DEVELOPMENT HEARING OFFICER (DHO)

PR-2023-008674
SD-2024-00163 – FINAL PLAT

REQUEST: Final Plat for Playa Del Sur

5-7(E)(2) Articulation and Alignment

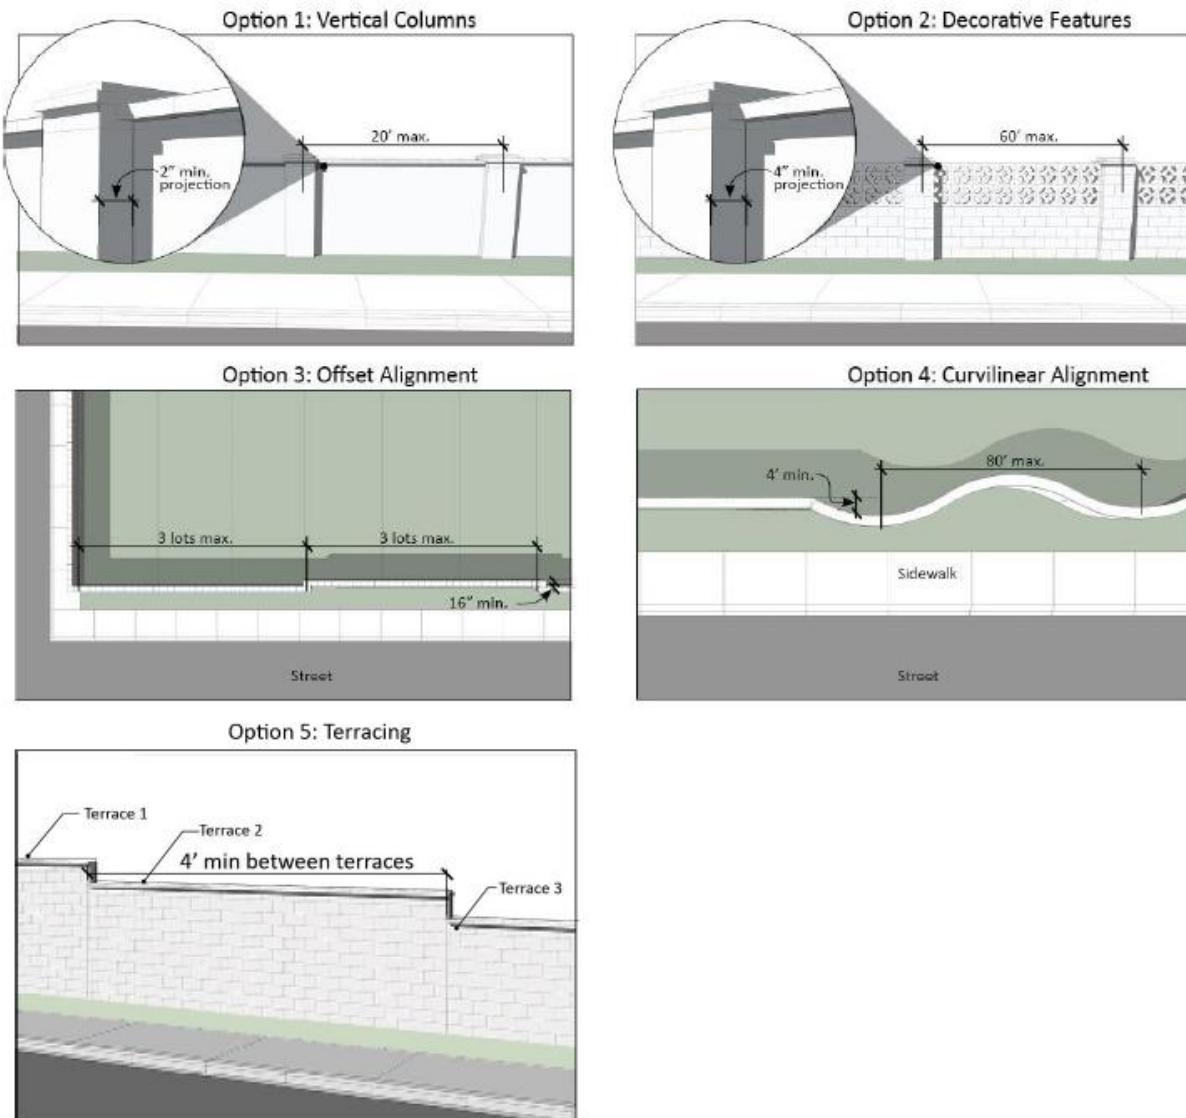
The proposed wall adjacent to the existing paved trail must comply with the following requirements from the DPM and IDO:

Portions of walls that obtain approval for a wall that exceeds the maximum height limits in Subsection 14-16-5-7(D) (Maximum Wall Height) or are required to exceed those limits and that face any public street, City Park or trail, Major Public Open Space, or major arroyo, shall incorporate at least 1 of the following features to break up the massing of the wall. (See figure below for illustrations of each option).

Vertical pilasters with a minimum projection of 2 inches from the public side of the wall surface at intervals of no more than 20 feet in length.

Decorative features, such as columns with a minimum projection of 4 inches from the public side of the wall surface at intervals of no more than 60 feet in length.

Offset in wall alignment of at least 16 inches, spaced so that no more than 3 consecutive lots have the same wall alignment.

Curvilinear alignments with a minimum distance of 4 feet between the outer surfaces of the wall. The outermost point of each curve shall have intervals no greater than 80 feet.

Terracing of walls with a minimum horizontal distance of 4 feet separating the vertical height segments.

5-7(E)(3) Wall Design

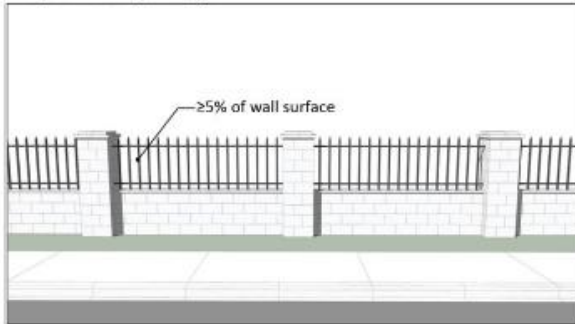
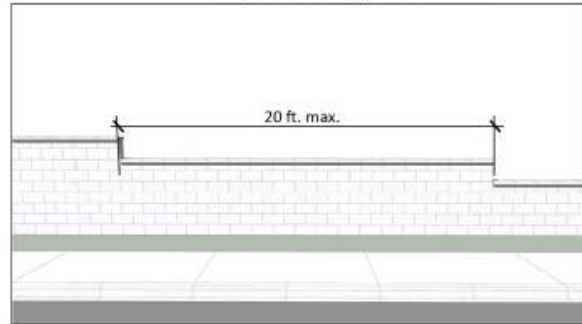
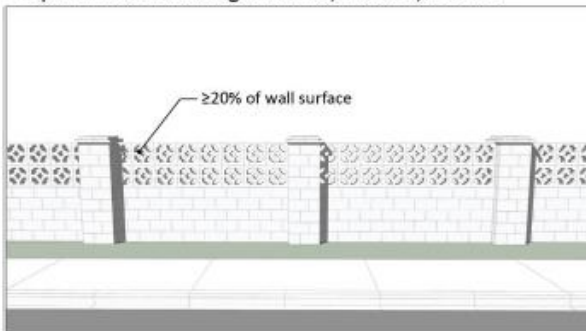
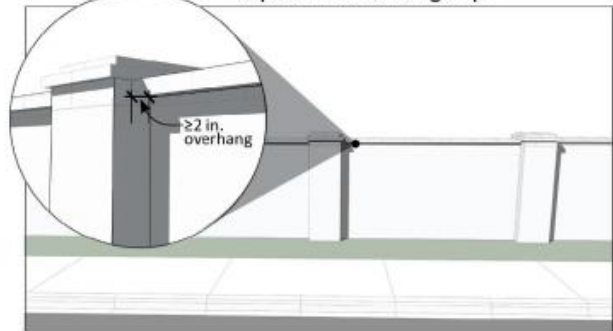
Any portions of a wall over 3 feet facing a public street, City Park or trail, Major Public Open Space, or major arroyo shall comply with at least 1 of the following options. (See figure below for illustrations of each option).

Openings distributed throughout the length of the wall equal to at least 5 percent of the wall surface, constructed into the surface or created by using see-through pattern blocks, tubular steel or wrought iron bars, wood, or other grillwork.

Variation in wall height at intervals of at least every 20 feet along the length of the wall. The normal stepping of the wall to accommodate grade change does not satisfy this requirement.

Use of a second and visually contrasting material, texture, or color along the length of the wall on at least 20 percent of its surface.

A continuous overhang cap along the length of the wall that projects at least 2 inches from the public side of the wall surface.

A variety of living shrubs, trees, and/or vines covering or overhanging at least 1/3 of the length of the wall in conjunction with a streetscape/landscape maintenance agreement between the City and the adjoining property owner and/or community association as part of a subdivision approval.
